## **Response to Action Item 3-75 Section 3.8**

### **SEB Clarification Questions Regarding APR 1400, DCD Tier 2, Section 3.8**

#### **Clarification Question #1 (AI 3-75.1)**

Figure 3.8-5 Liner Plate and Anchorage System

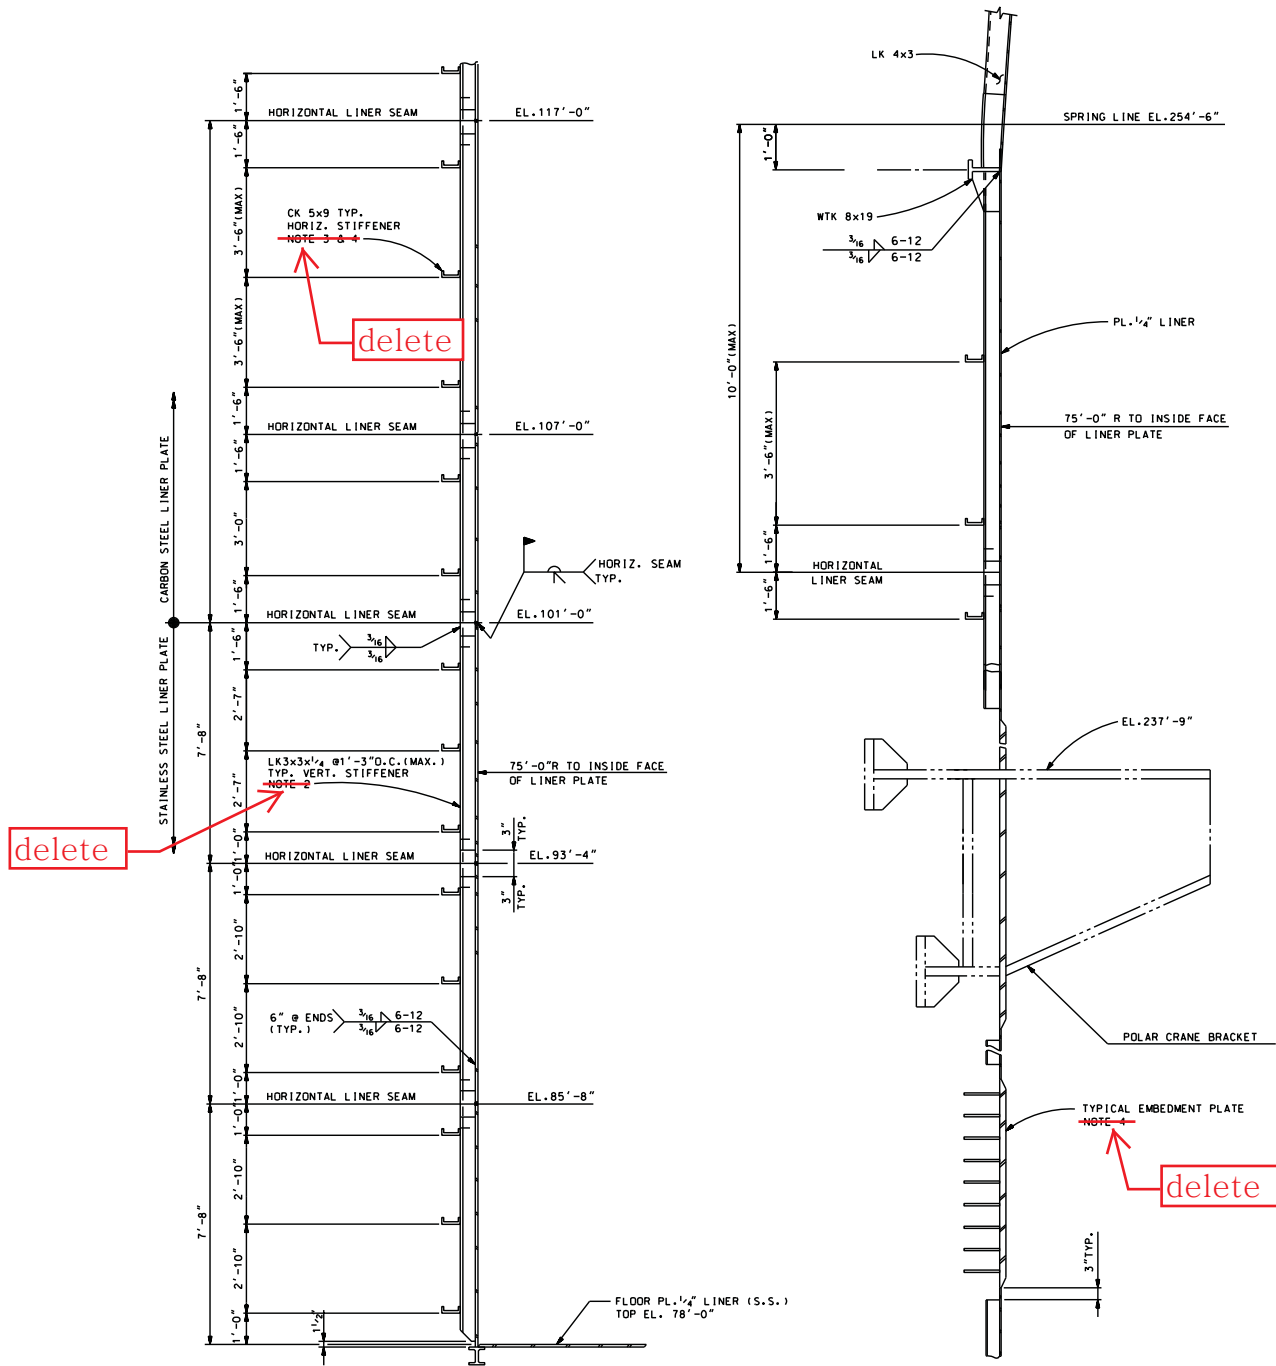
- a) Figure 3.8-5, "Liner Plate and Anchorage System," on page 3.8-113 of the DCD, mentioned a few notes associated with the type of stiffeners and how the liner plates are typical embedment. However, the staff was not able to locate the descriptions of the notes. The applicant is requested to address where this information is located.
- b) Additionally, since leak-chase channel has been identified as a potential degradation issue according to Information Notice 2014-07, the staff is requesting the applicant to explain how this issue is being addressed in Section 3.8 of the DCD application.

- a) The notes are errata. In general, these notes are provided in detailed design drawings. Figure 3.8-5 will be revised to eliminate mention of notes.
- b) As shown in DCD Figure 3.8-7 Detail 1, the liner plates of the containment floor are typically installed by full penetration welding to H-beams which are embedded in the concrete basemat. The top of the containment liner plate floor is covered with fill concrete. Therefore, leak chase channels are not included in the design of the containment floor for detection of leakage because floor weld seams are inaccessible. The information notice is not applicable to the APR1400 design.

DCD Tier 2, Figure 3.8-5 will be revised as indicated in the attachment associated with this response.

Figure 1. Typical Section of IRWST Wall

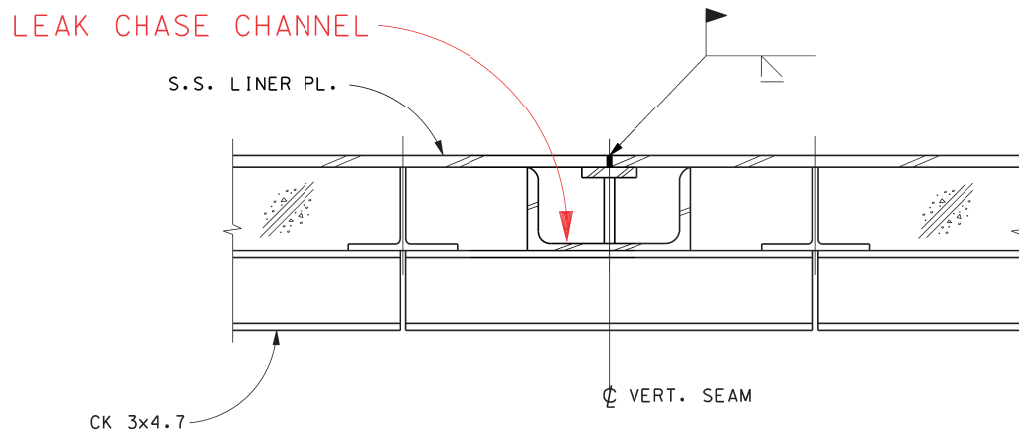
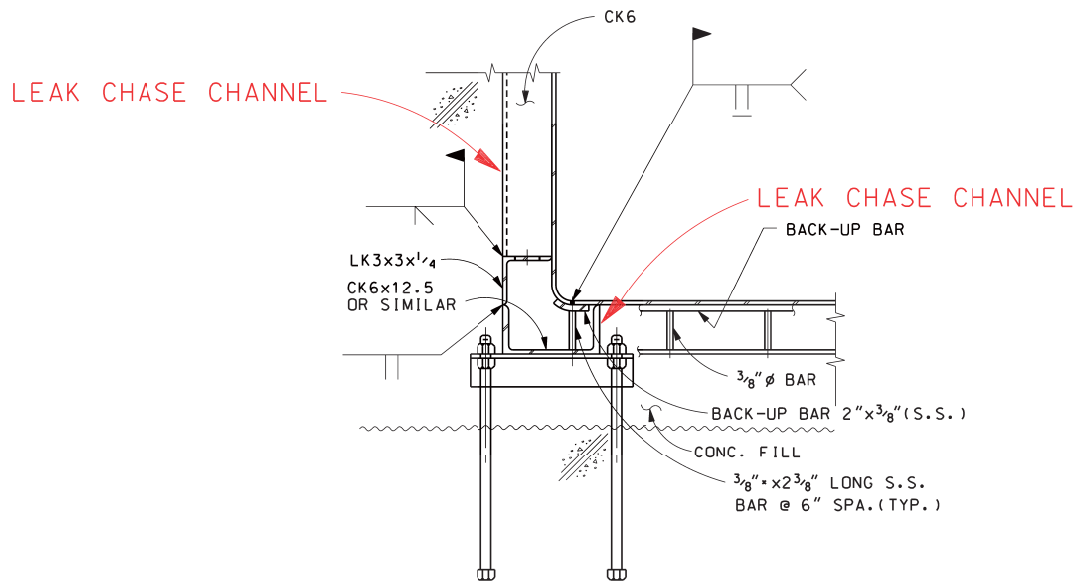
In DCD Tier 2, Section 3.8.3.1, "IRWST," the applicant stated, "The IRWST is lined with a stainless steel liner plate to prevent leakage." Please confirm whether there are leak chase channels in the IRWST.

Leak chase channels are included in the design of the in-containment refueling water storage tank (IRWST). The leak chase channels are located on the back side of welded seams between stainless steel liner plates.

The details of leak chase channels in the IRWST, and the containment liner plate floor, are shown in the attachment associated with this response.

Figure 3. Section of Containment Building around IRWST

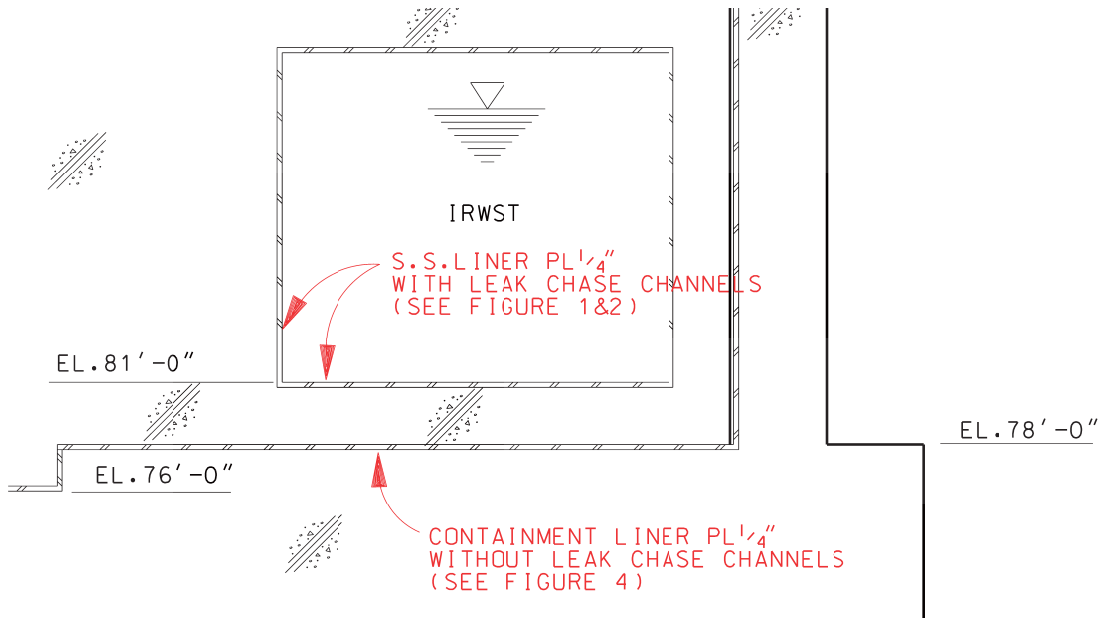
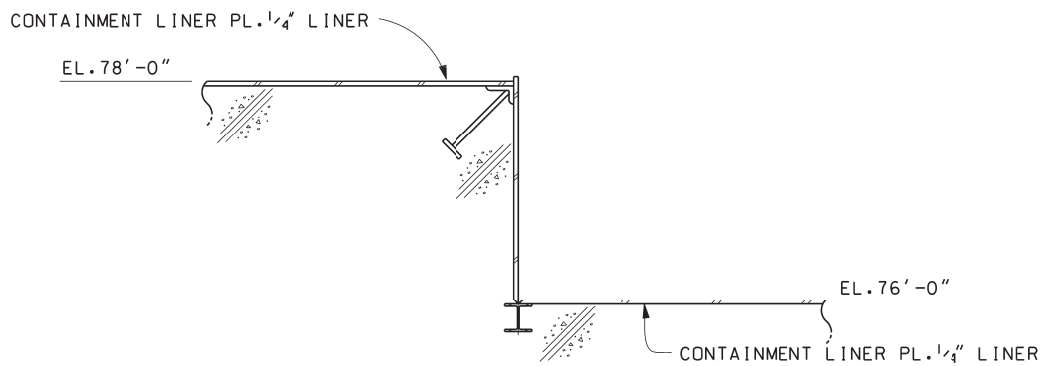
Also, the staff reviewed the connection between the containment liner and the basemat (See DCD Figures 3.8-5 through 3.8-7, 3.8-10, and 3.8-11), and was unable to determine whether leak chase channels are included as part of the design. Such leak chase channels are typically used in containments to allow for pressure testing of the seam welds for leak-tightness. The applicant is requested to confirm whether leak chase channels are included at the welds of the containment liner along the top of the concrete basemat.

As shown in DCD Figure 3.8-7 Detail 1, the liner plates of the containment floor are installed by full penetration welding to H-beams which are embedded in the concrete basemat. The top of the containment liner plate floor is covered with fill concrete. Therefore, leak chase channels are not included to the design of the containment liner plate floor for detection of leakage at the seams of the containment liner plates.

During construction, pressure testing of welded seams of the containment liner plate floor is performed by vacuum box testing in accordance with ASME Section III, Division 2, Subsection CC.
